Serpentine Crescent - Gap in Noise Wall and proposed link road and tunnel intersection

Figure 3: Taken from RMS website with amendments showing proposed outcome within 100M of Serpentine Crescent

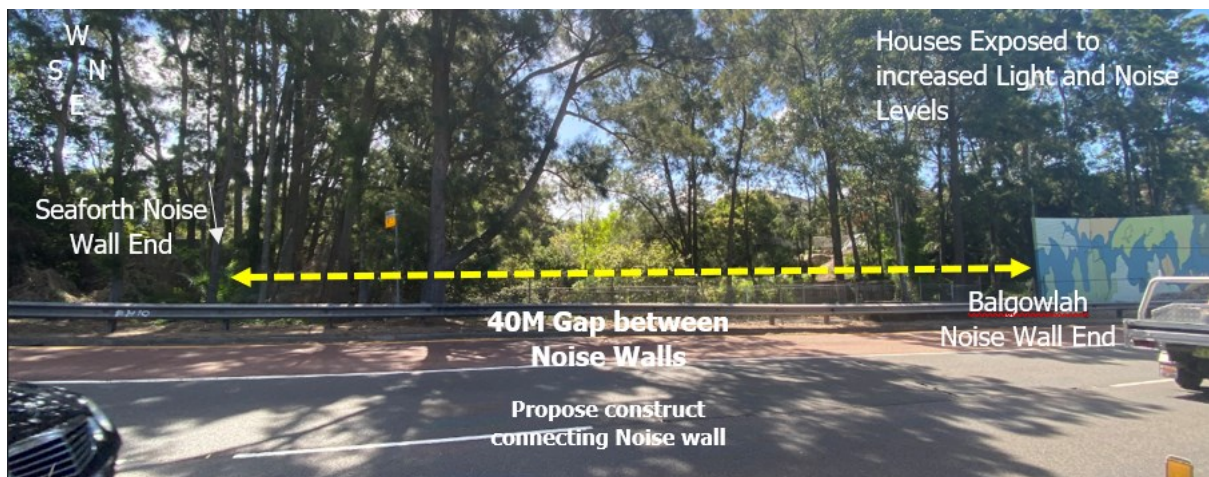
- **construction of a new access road between BCD and Sydney road to provide access to the tunnel** (increased traffic from Manly-City – see Figure 5)
- **a new tunnel entrance on BCD** (increased traffic from Manly Vale – City – see Figure 5)
- **a widening of the current BCD from 6 lanes to 12 lanes** (to facilitate above – see Figure 3 and 4)
- **motorway facilities** (heavy plant and machinery - see Figure 3 and 4)
- **exhaust stack** (air pollution - see Figure 3 and 4)

The additional noise generated at the intersection of the link road, Burnt Creek Deviator itself plus it's proposed widened access roads to the tunnel, combined, would make this location the highest noise zone area of the Balgowlah Connection to the Beaches Link. This is the only unprotected residential area along the BCD. The location also has a detrimental impact on the visual experience which will draw increased east-west traffic light directly into the line of vision of properties, and is particularly discomforting at night.

Based on the reasons above and facilitated by the savings made by relocation the link road and tunnel entrance, I request as a minimum, the construction of a noise wall to minimise noise levels and light pollution for the residents of Serpentine Crescent.

Figure 4: EIS showing 40M gap and impact of works near this 40M gap

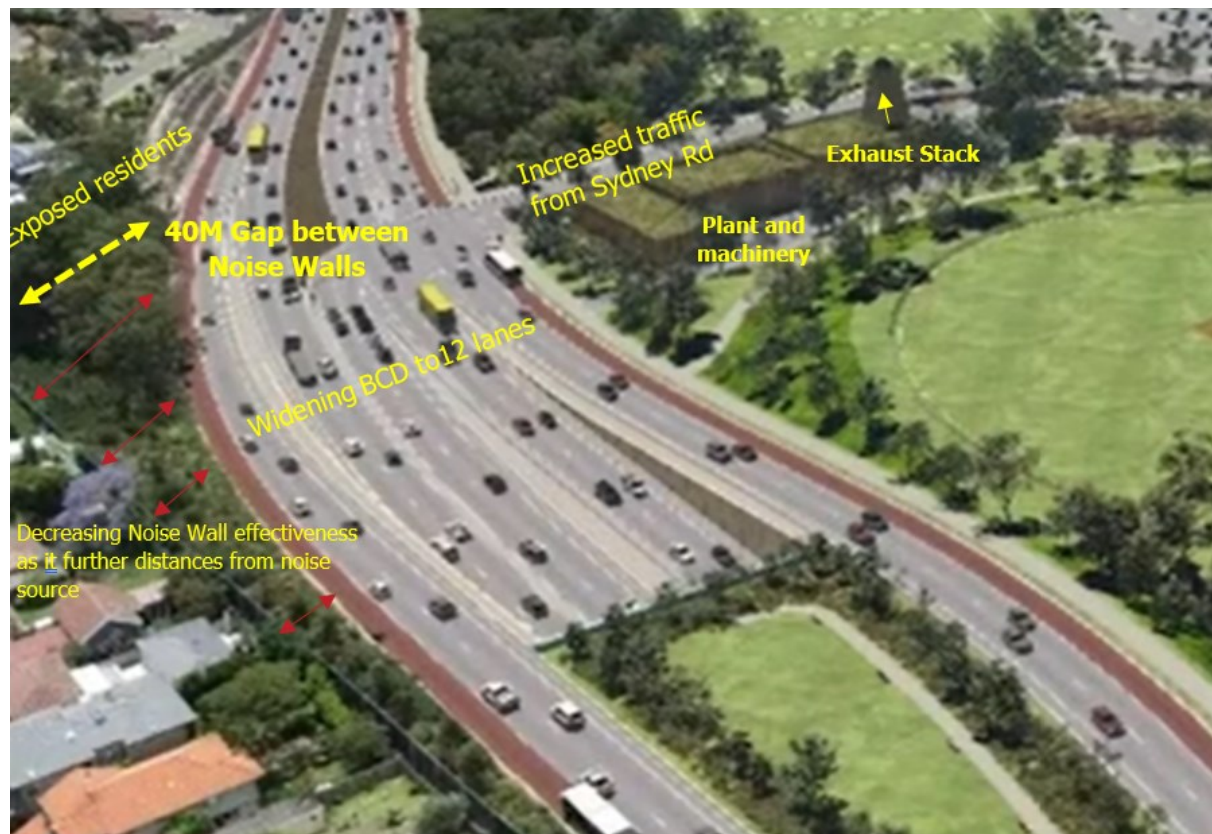
However, what appears to have been overlooked is the impact on the area near the creek and the residents of Serpentine Crescent. The current 40M gap is located along the only stretch of unprotected residents on the 1.5Km long BCD where the Beaches Link Environmental Impact Statement (EIS) now proposes the following works:

Figure 5: Outtake from EIS showing increased traffic forecast at creek area where gap in noise wall exists

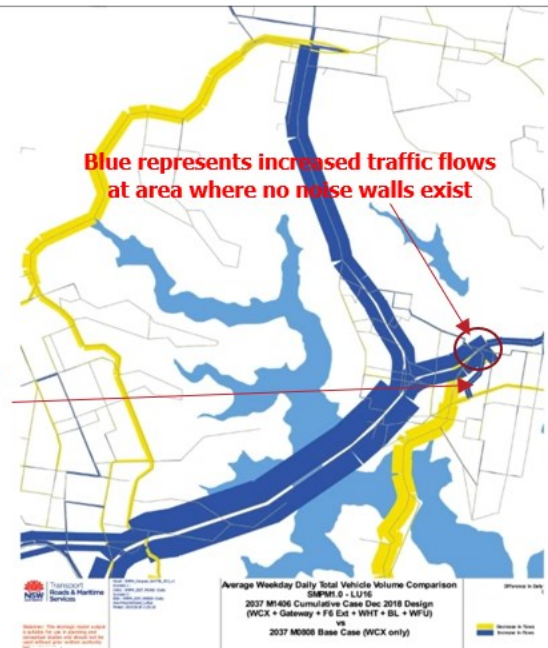
The latest proposal indicates a widening of the BCD from 6 lanes to 12 lanes to facilitate the tunnel entrance with an intersection of a link road to bring traffic from Sydney Rd. This will essentially bring the volume of traffic which currently passes the intersection of Sydney Road and BCD back to the unprotected creek area and entrance to the tunnel.

This means 65-70% of traffic on Sydney road will move through link road
- As a result of Beaches Link:
 - Traffic demand is forecast to increase by up to 15%.
 - Average travel speeds are expected to improve by around 50-75%
 - Bus travel speeds would also improve as a result of reduced general traffic congestion
